ADDENDUM No. 3

**ORG #207 – San Jacinto Elementary School - Renovation
ORG #273 – Pleasant Grove Elementary School – Renovation**

DALLAS INDEPENDENT SCHOOL DISTRICT

11/01/2024

KEY PLAN

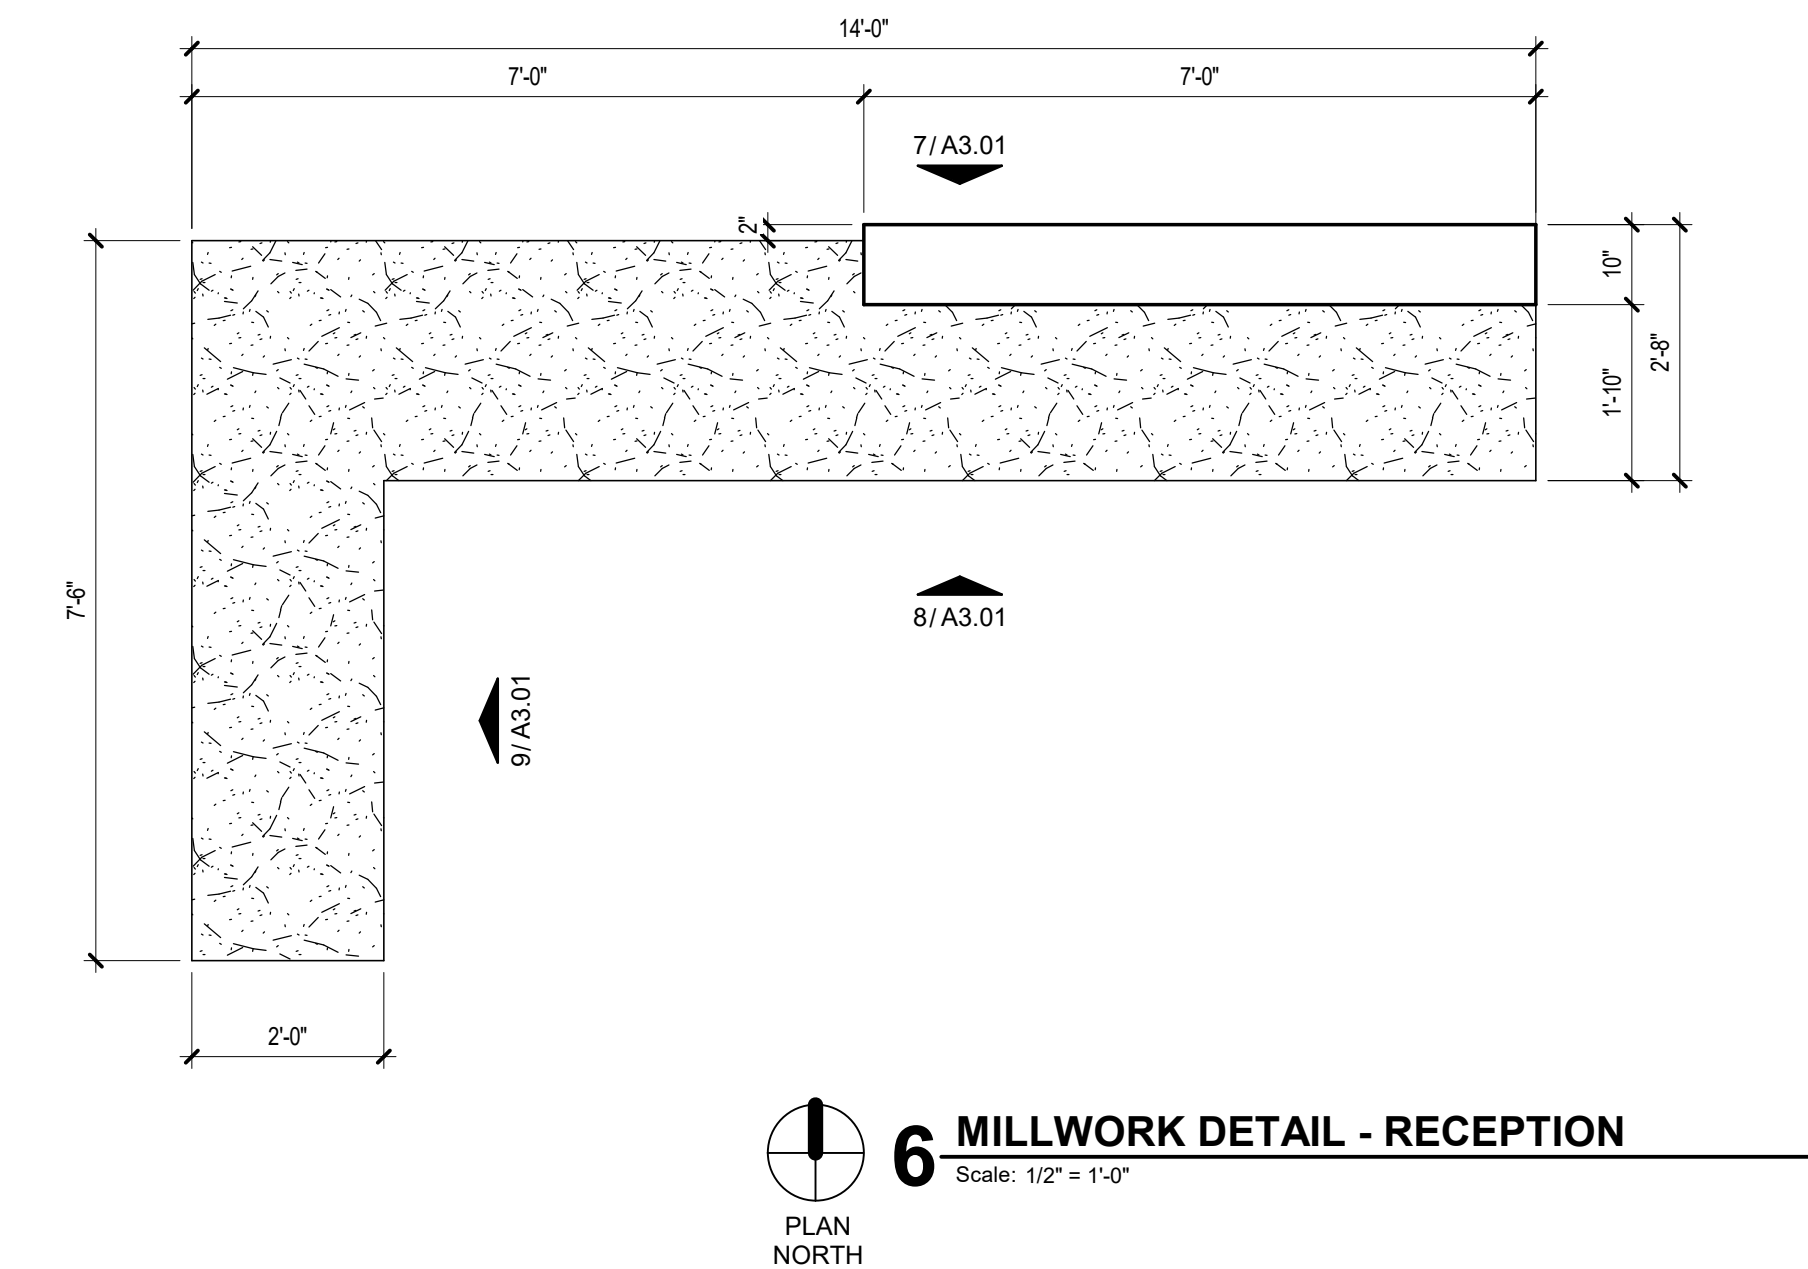
- Replace sheet with the revised attached A3.01.
 - Carpet to be Mohawk Datum in color Basalt as indicated.
- Replace sheet with the revised attached A1.01.
 - ALTERNATE: Mild-detergent medium power wash to be done at front of building only as indicated.
 - ALTERNATE: Provide sandblasting, prime & repaint all handrailing, guard railing and exposed metal at ramps as indicated.
